Service Information

Category P	Repair Guidance	Ref. No. R021/14	Page 1 of 2
Coverage <input type="checkbox"/> Distributor only <input checked="" type="checkbox"/> Please inform your dealers		Date Issued February 17, 2014	
Please convey this information to your <input type="checkbox"/> Director <input checked="" type="checkbox"/> General Manager <input checked="" type="checkbox"/> Warranty Dept. <input checked="" type="checkbox"/> Parts Dept. <input checked="" type="checkbox"/> Training Dept. <input checked="" type="checkbox"/> Field Rep.		Date Revised	
Applicable Model CX-5(KE)		Applicable Countries or Specifications European Models

Subject: Grinding Noise from Front Brake

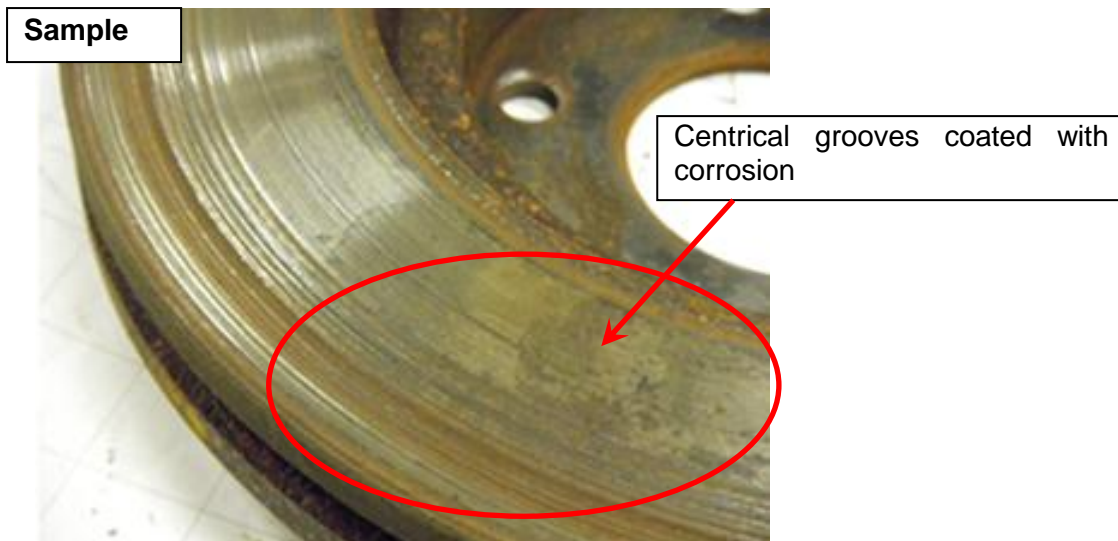
MASS PRODUCTION CHANGE

The shape of the front dust cover has been changed.
